*Request for Competitive Solicitations
Rebid Sands SLR Roadway and
Drainage Pilot Project, Big Pine Key,
Monroe County, Florida
RFP-484-0-2023/la
ADDENDUM NO.5
March 20, 2023*

Questions, Responses and Clarifications:

Note: Bid sheets have been revised. Plan sheets G-8B, RD-4B, S1-B, SQ-1B, S-12B, TC-1B, TC-2B have been revised.

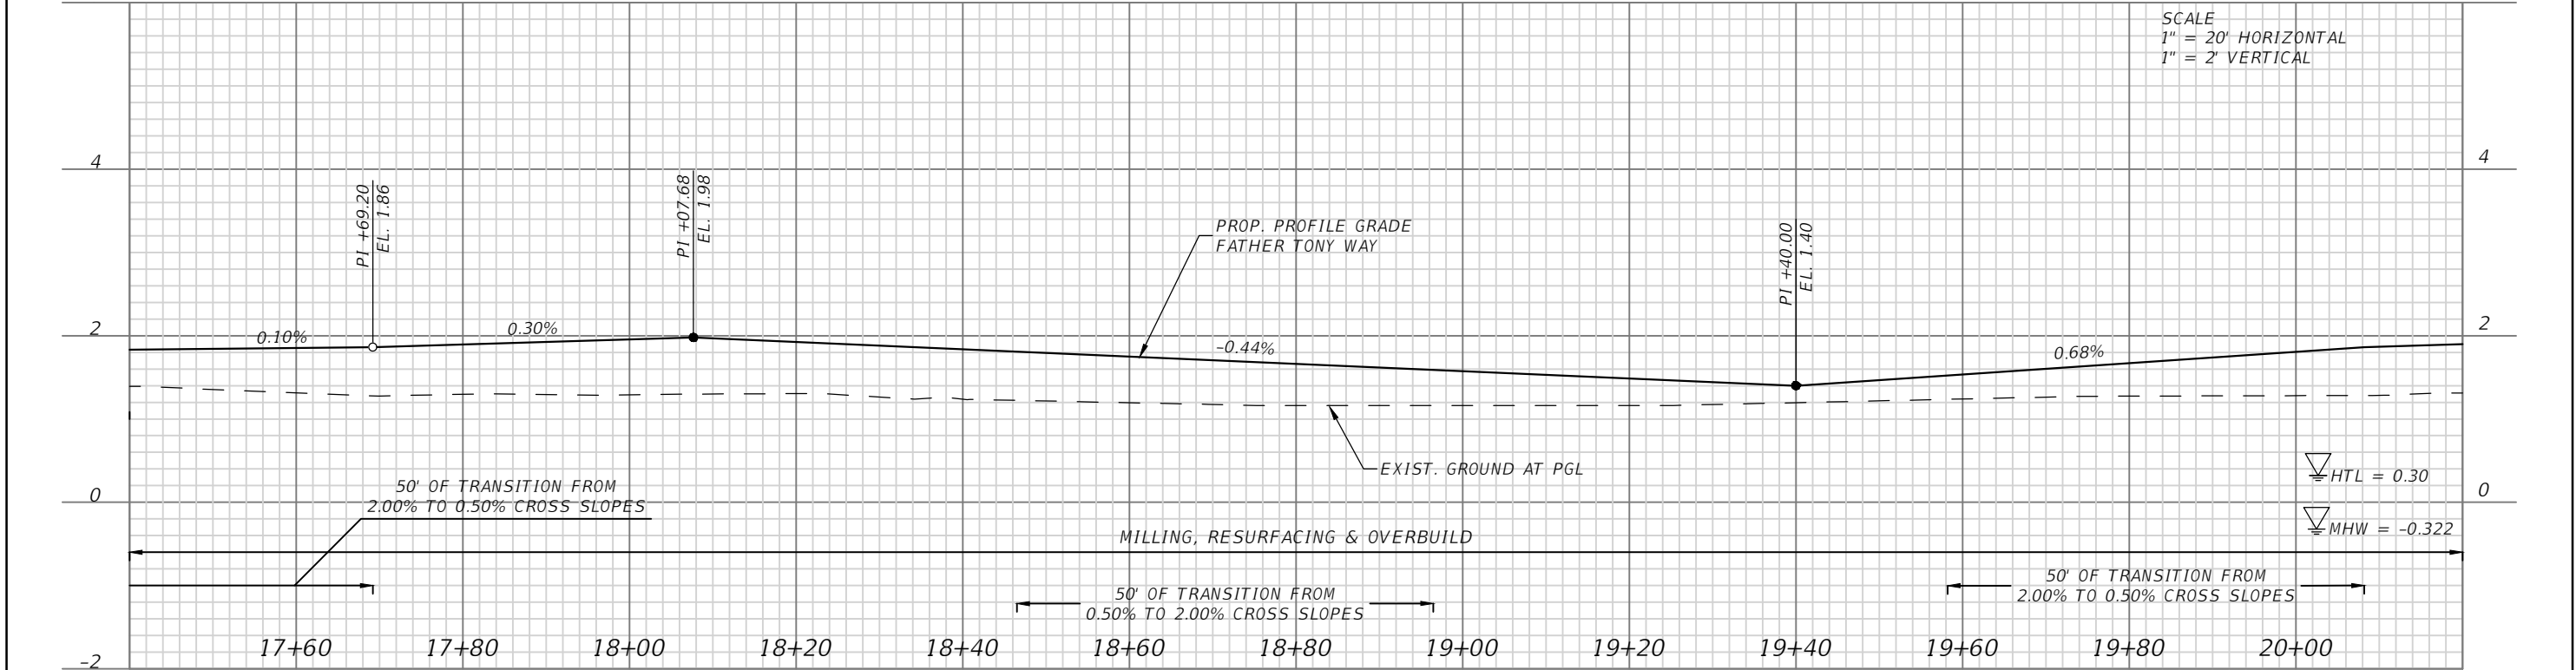
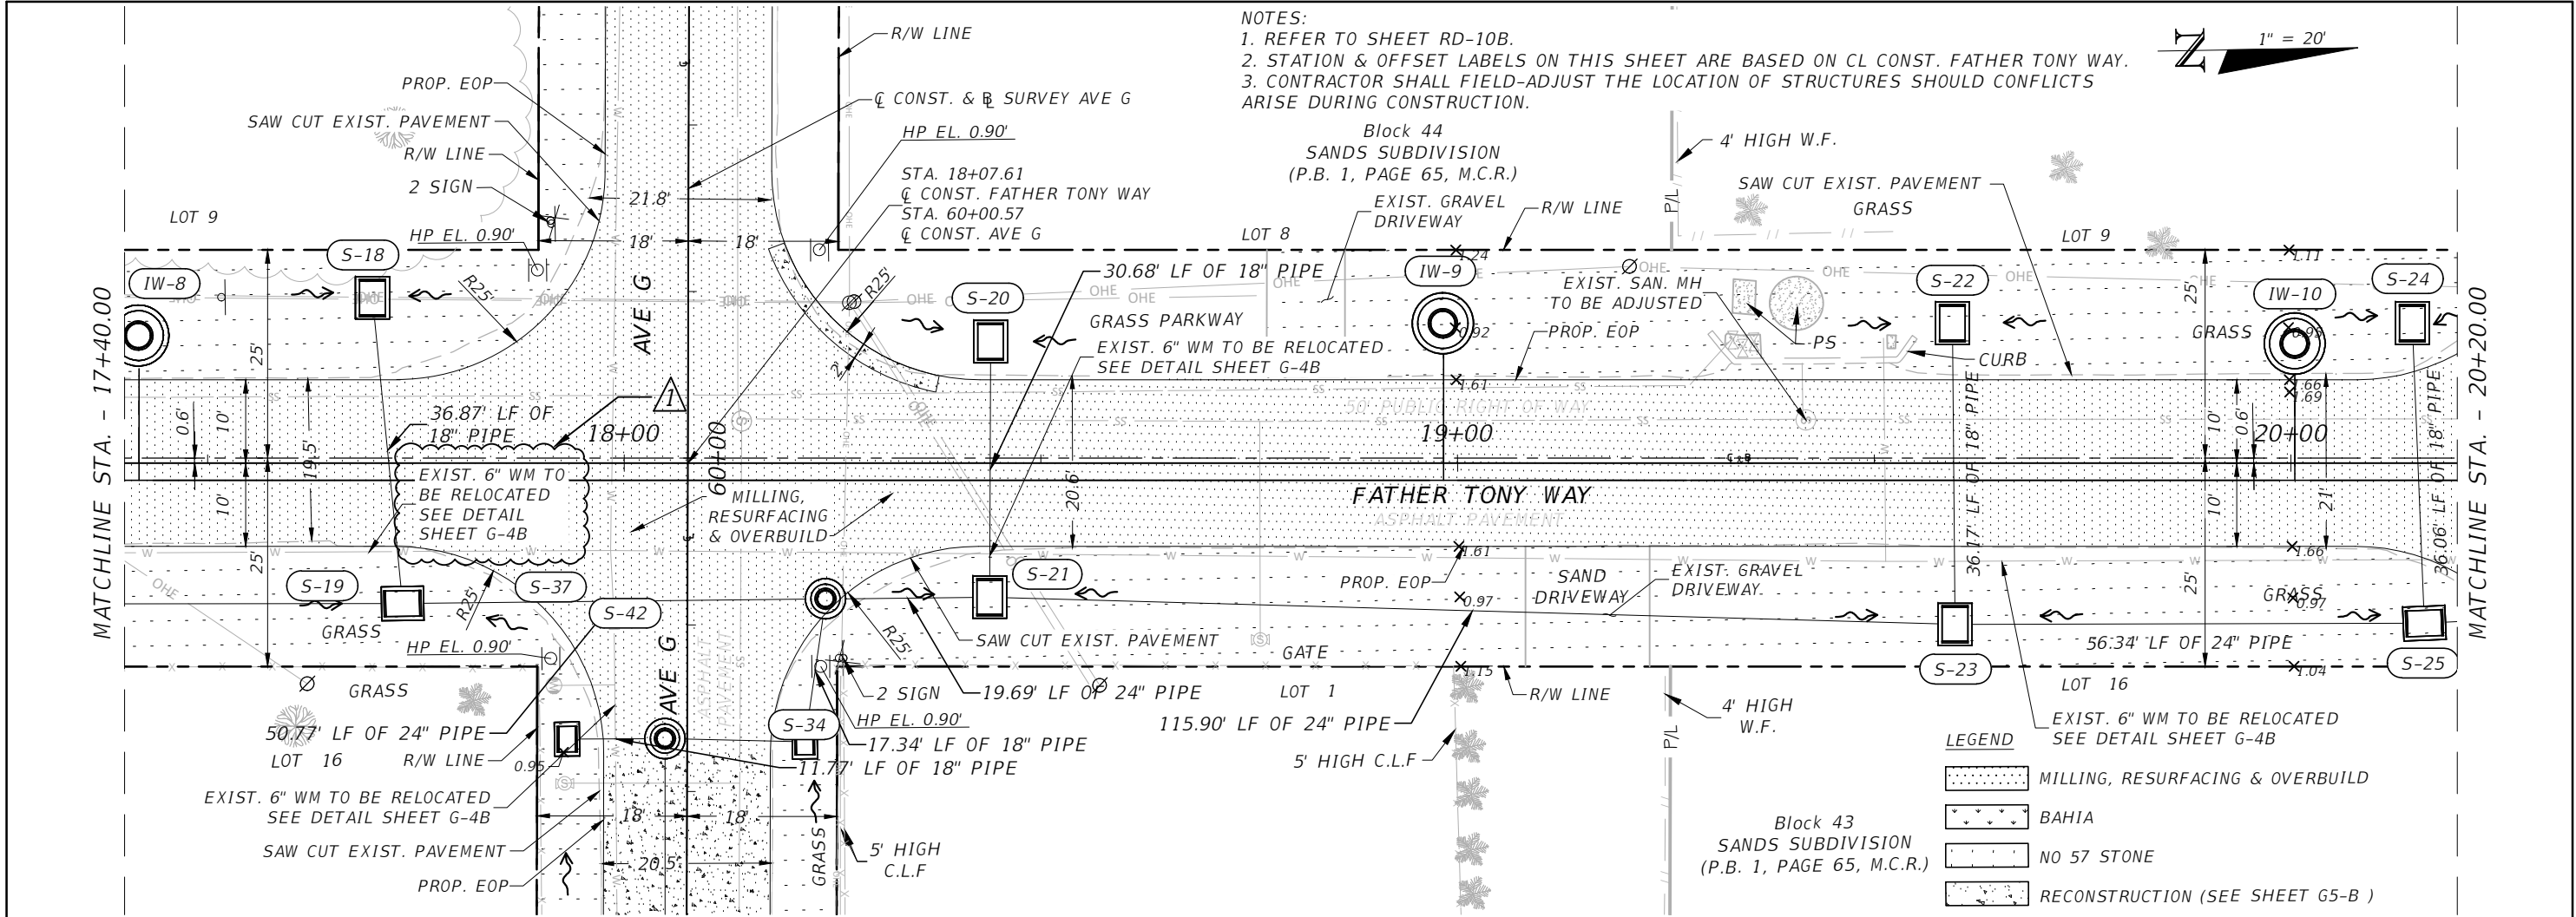
Q8: The new roadway profile differs from the existing profile in several areas creating drop offs greater than 1.5”. Sheet TC-1B, Work Zone Special Notes # 7 states that this is to be handled by Index 102-600 which requires barrier or slopes with base material. There is not enough room in the roadway template for this. With the TCP being assigned to the Contractor, will the County allow a detour with one way traffic on one side of the road. Residents would always have access to their residences. This will reduce the cost of the project by allowing the paver to reduce his number of mobilizations by paving the side of the street at one time (this would not be allowed under Paving Note 1 on sheet G-8B). But with the drainage &

utility work required, the 3 day resurfacing requirement is not realistic & will greatly increase the cost of the project. Also Avenue G has several manholes that are to be installed in the traffic lane. This will require a road closure with detour while these are installed. Please confirm that a detour will be allowed in the Contractor's TCP with one way traffic on the affected roads at all times.

R8: Refer to revised sheet G-8B. Paving Note 1 on Sheet G-8B has been revised to allow deviations from the recommended paving schedule pending county approval. See revised sheet G-8B Note 5 - allowing access to driveways at all times. TTC Plans provided are for bidding purposes. Contractor is responsible for providing complete TTC plans for approval by the county per Sheet TC-1B Note 2 (Addendum No. 3). Detours are allowed and must be in compliance with FDOT and MUTCD standards and approved by the county as per Sheet TC-1B Note 1.

S-1B

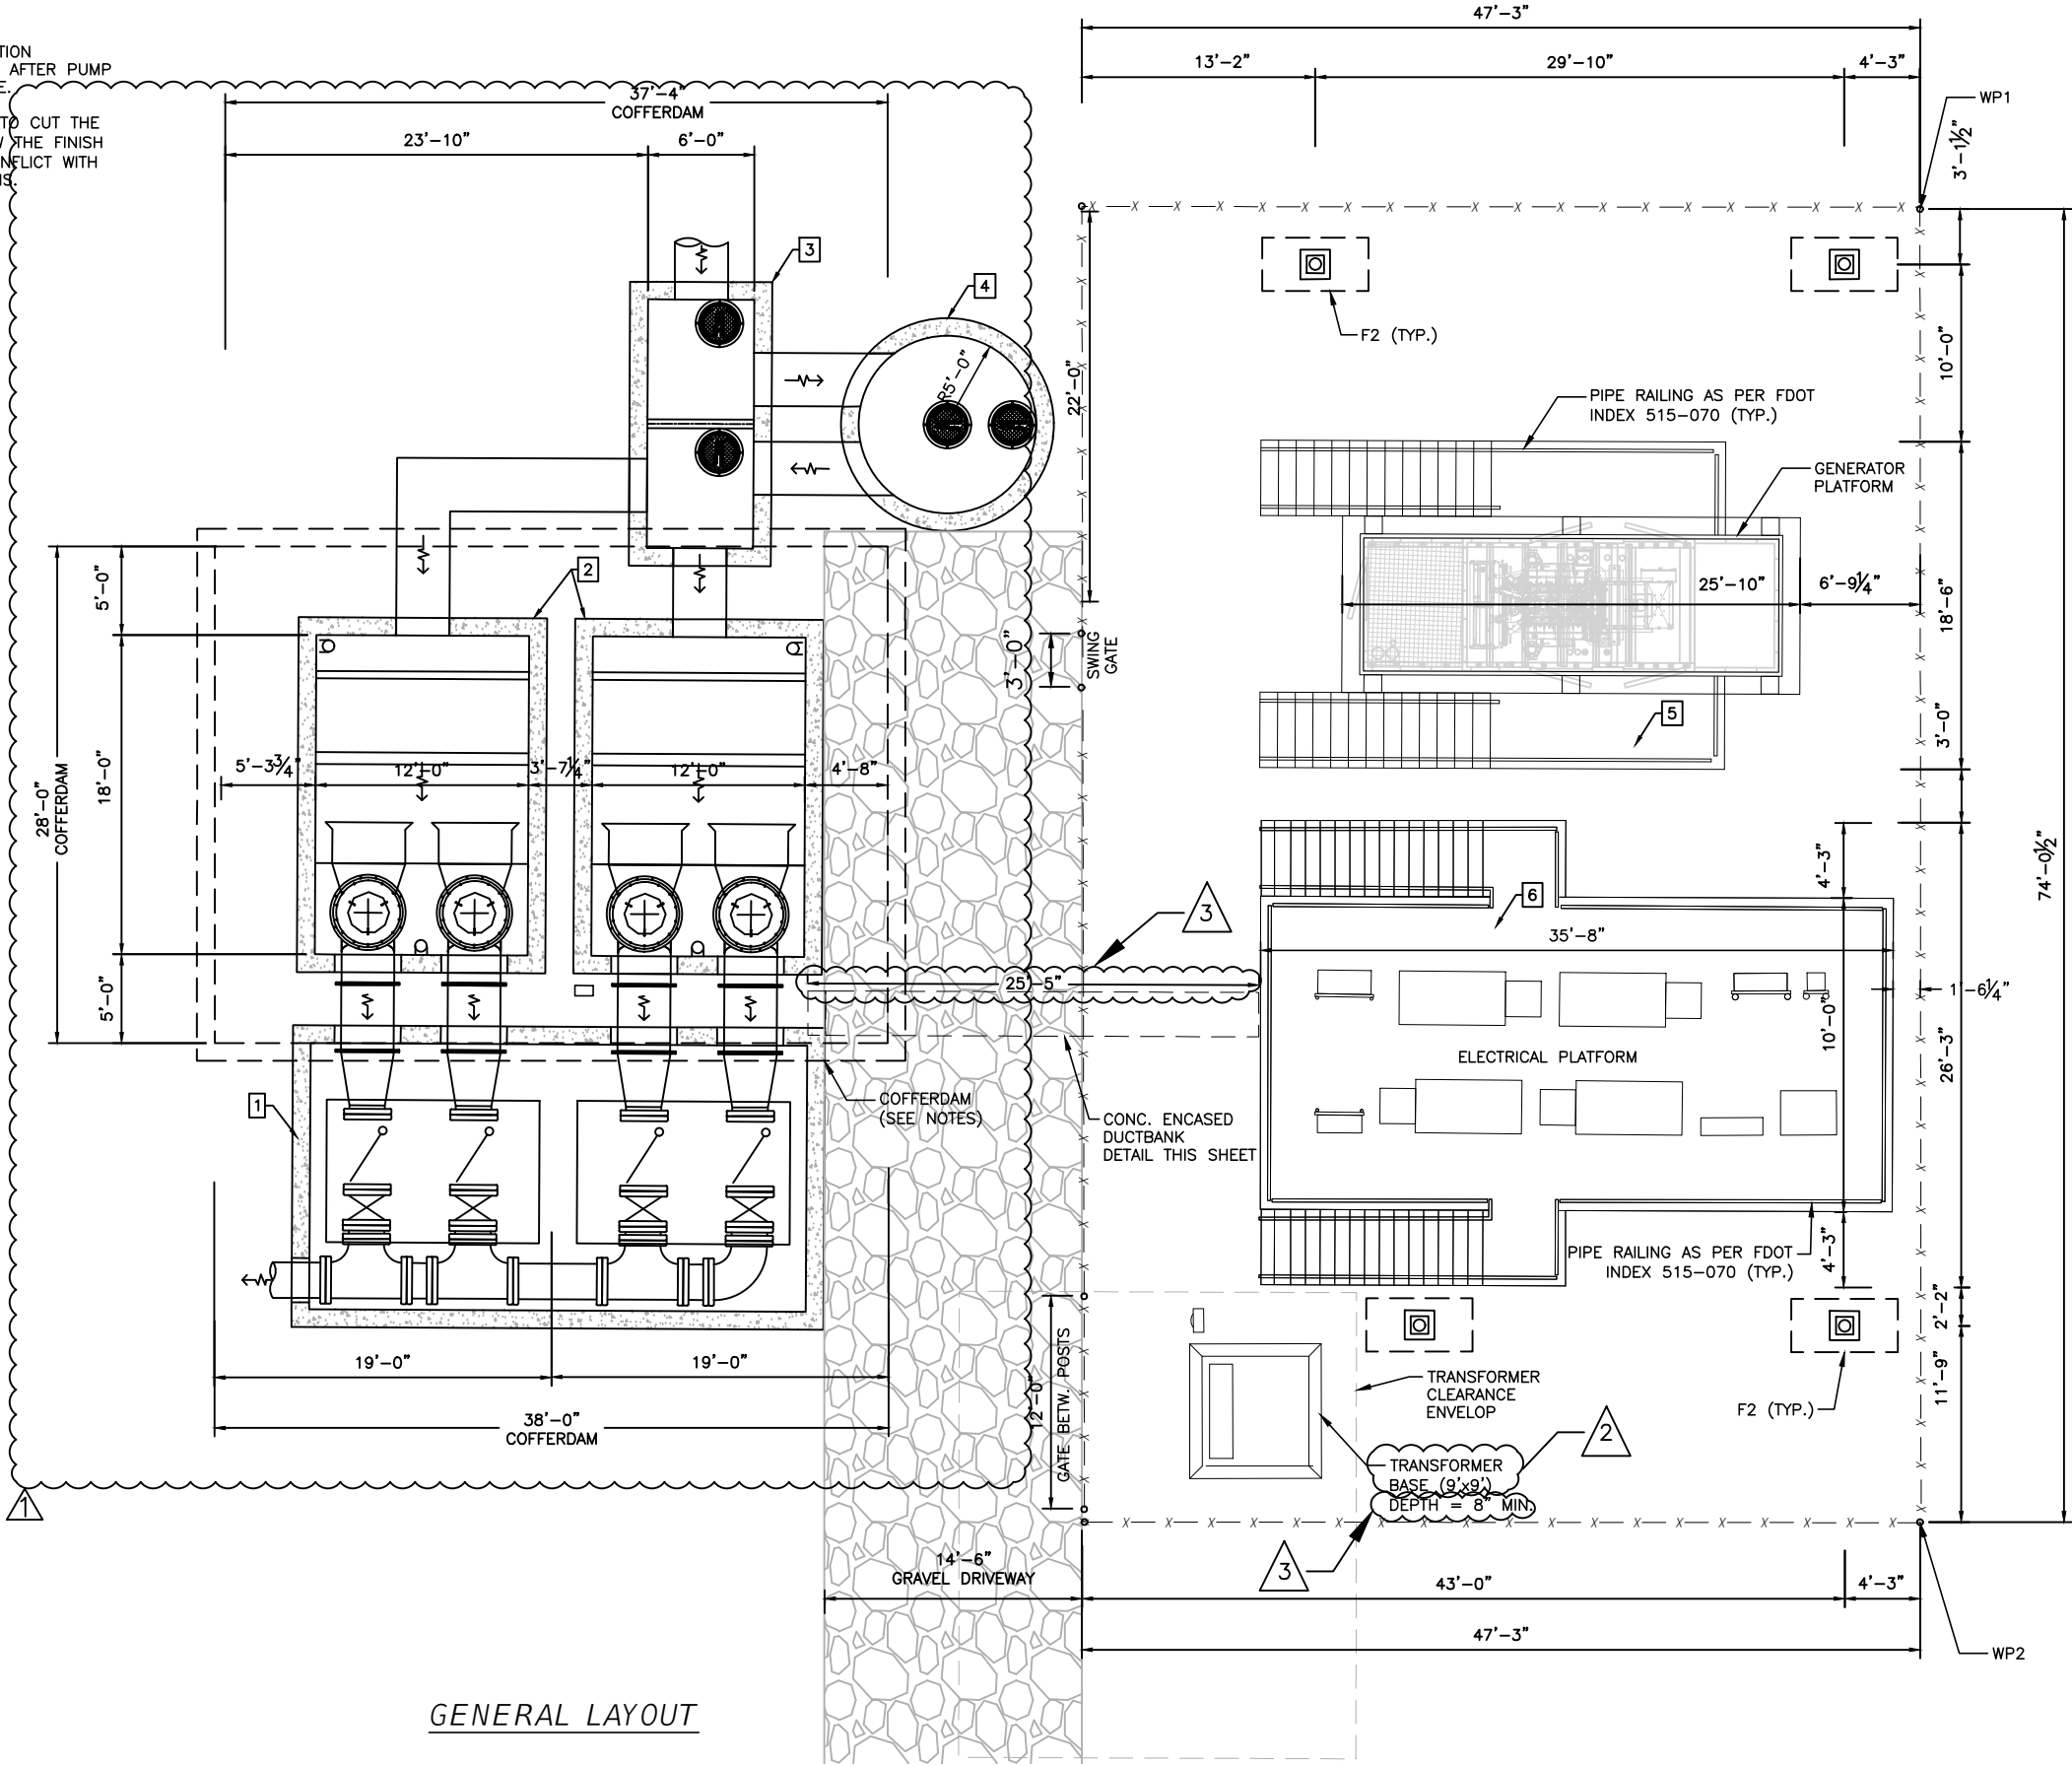
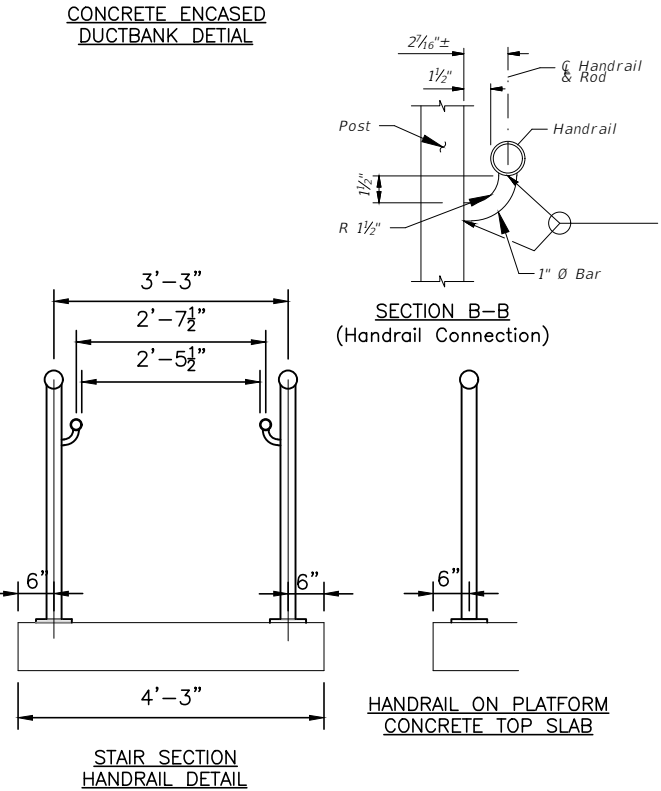
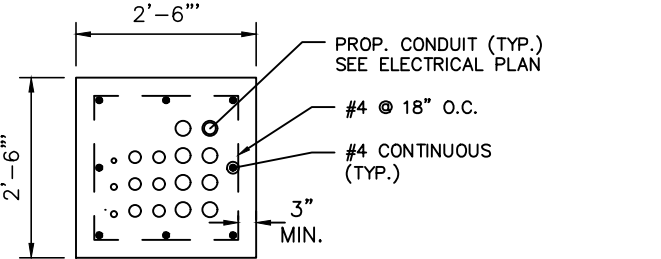
Q1: Addendum 2 added the ductbank shown on Sheet S-1B. Please provide the length of the ductbank, and the pay items for the concrete, reinforcing steel and conduit.

Q3: Addendum 3, Q2 gave the length & width of the transformer base. Please provide the depth.

R1: Refer to revised bid sheet and plan sheet SQ-1B. Ductbank length is 26 LF per revised sheet S-1B. Pay item 630-2-11 has been added for 26 LF of conduit inclusive of concrete and reinforcing steel.

R3: Refer to revised plan sheet S-1B – Minimum depth for transformer base is 8”.

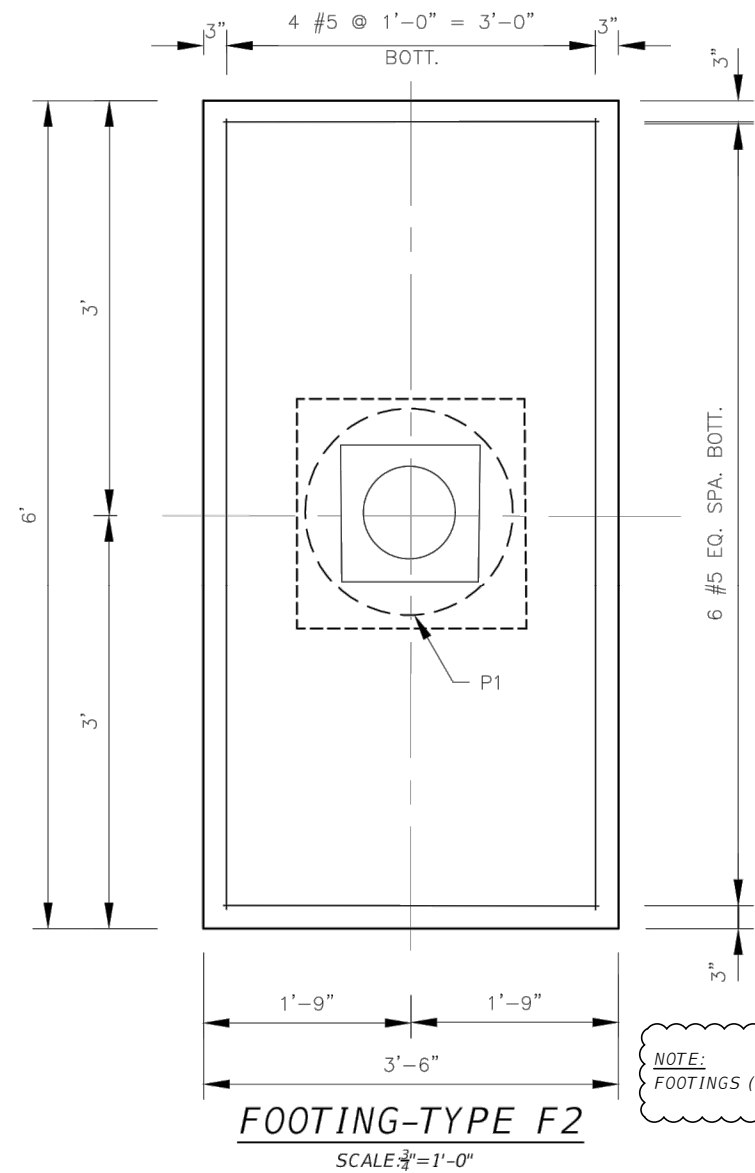
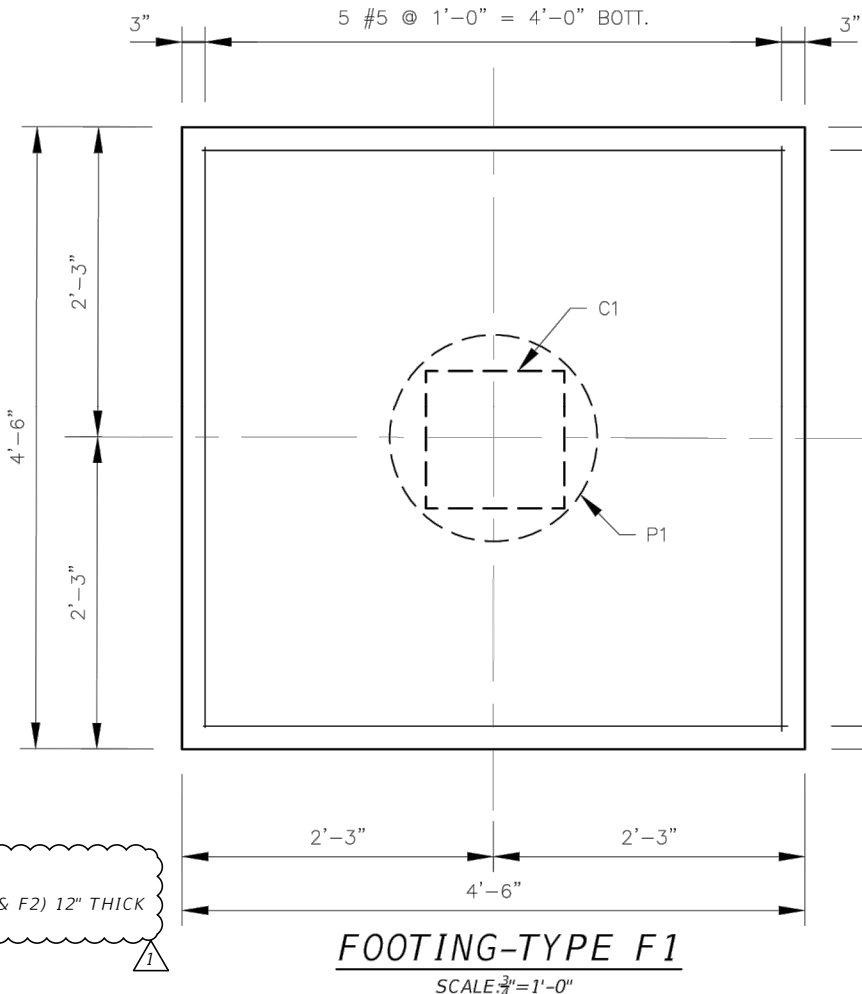
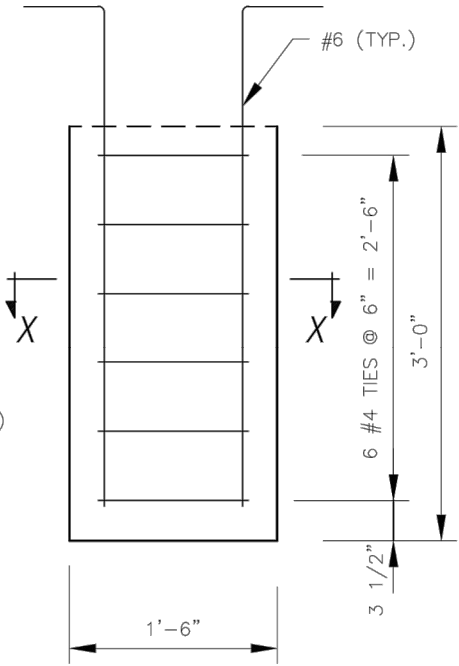
Q2: Addendum 3, Q3 asked for the depth of Footing F2, your answer referred to sheets S-8B & 10B which is for Footing F1 for the platforms. F2 is the foundation for the light poles. Please provide its depth.

R2: Refer to revised plan sheet S-12B. Footing thickness is 1ft per note on revised Sheet S-12B. Depth of 3ft is provided per detail P1 on sheet S-12B.
